PLANNING & ZONING BOARD STAFF REPORT

2419 North Federal Highway

Meeting	File No.	Application Type
May 18, 2026	2025-213-SPR-WAI-LV4 2025-214-USE-PZB	Level 4 Site Plan; Conditional Use, For Free Standing Multiple-Family Housing
Property Owner	Authorized Agent	
Ultra Luxury Townhomes, LLC	Jeffrey Costello, AICP JC Planning Solutions

Provide a recommendation to the City Commission for a Level 4 Site Plan Application, including a Landscape Plan, Architectural Elevations, Four Waivers, an Internal Adjustment, and a Loading Determination, to construct a 47-unit multiple-family townhouse-type condominium development with a mix of two- and three-story buildings; and a Conditional Use to allow free-standing multiple-family development in the General Commercial (GC) zoning district.

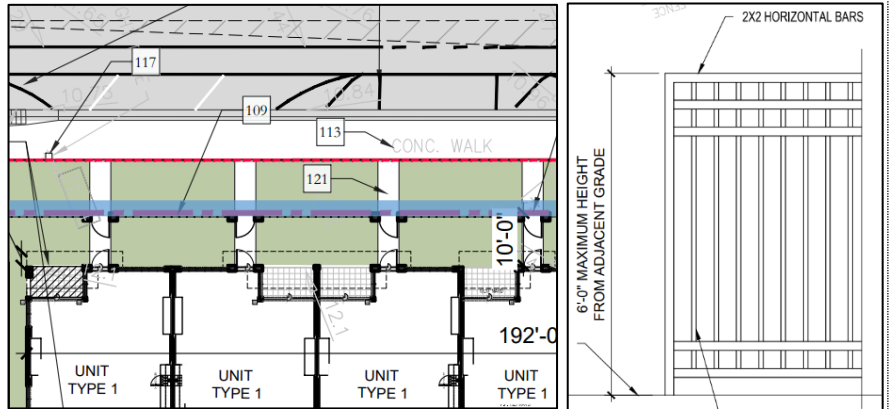
The intent of the townhouse design standards, such as the four-foot offset requirement, is to prevent long rows of repetitive design, reducing the overall mass, and articulating each townhouse unit (shown in blue to the right). Rather than offsetting each townhouse unit, the project proposes to provide a four-foot articulation within each unit (shown in purple to the right).

The offset requirement applies to both the rear and front of the structure; the structures along North Federal Highway appropriately articulate the townhouse mass both to the front and rear similar to the intent of offsetting the townhouse units (shown to the right). All the facades facing the driveways have this four-foot articulation within each townhouse unit, breaking up the overall massing; several rear and side elevations, particularly along the south and east edges, do not provide the same level of articulation as the driveway-facing elevations.

The Board should consider if the proposed four-foot articulation within each unit adequately meets the intent of the offset requirement, or whether the lack of rear and side articulation weakens the request.

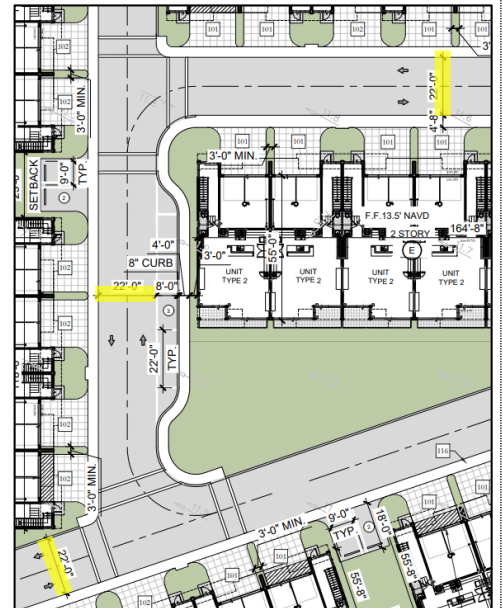
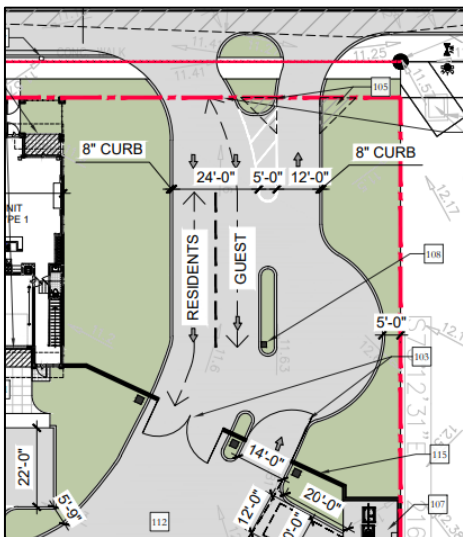
The project proposes 22-foot private drive aisles, whereas the code requires a minimum width of 24 feet. Drive aisle width requirements are established to ensure safe two-way circulation and adequate maneuvering for vehicles backing out of parking spaces. The applicant has proposed a maneuvering diagram that illustrates larger vehicles will be able to effectively maneuver through the site. However, the reduced width occurs in areas where parking is located on both sides, which may create conflict between parked vehicles, backing movements, service vehicles, and emergency access. Fire has also noted potential concerns if a fire truck blocks circulation while accessing a hydrant during an emergency.

The Board should consider whether the reduced drive aisle width will negatively affect maneuverability and safety within the development. The requested reduction applies only to private internal drive aisles and does not directly affect the public right-of-way.

6. LDR Section 4.6.2(B): Residential Building Separation

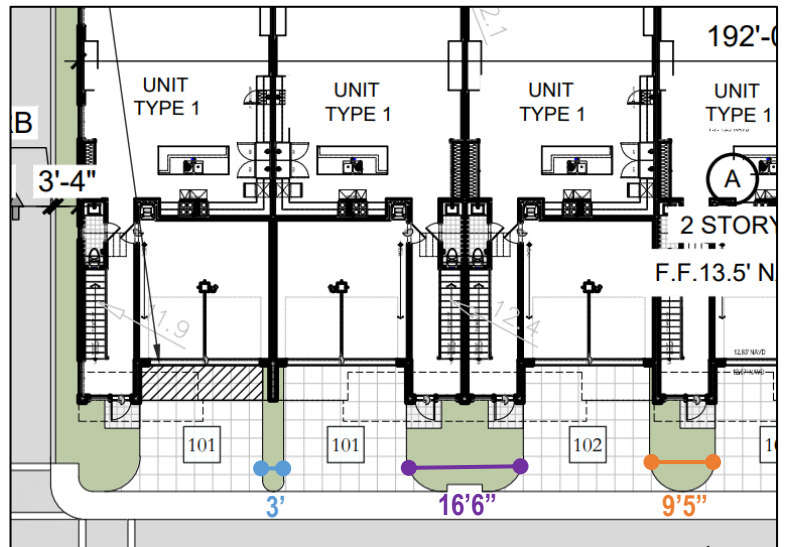
The LDR establishes regulations for the distance between residential buildings to provide adequate separation between structures to allow for light, air, and open space; and to provide for aesthetically pleasing design relationships among buildings which are constructed within a townhouse, apartment, or condominium residential development. The required distance separation is a function of the proposed length and height of the buildings, whereas the larger the building the more separation is generally required. Based on the dimensions of the proposed structures, a separation between buildings ranging from 32 feet to 38 feet would be required. The applicant instead proposes a distance of 25 feet between Buildings A, B, C and D, and 12 feet, 4 inches between Building E to the Recreational Center. This request has no impact on the perimeter setbacks.

The Board should consider whether the proposed building separation provides adequate light, air, privacy, and open space between buildings, or whether the site would benefit from fewer units or a revised layout with greater separation between structures.
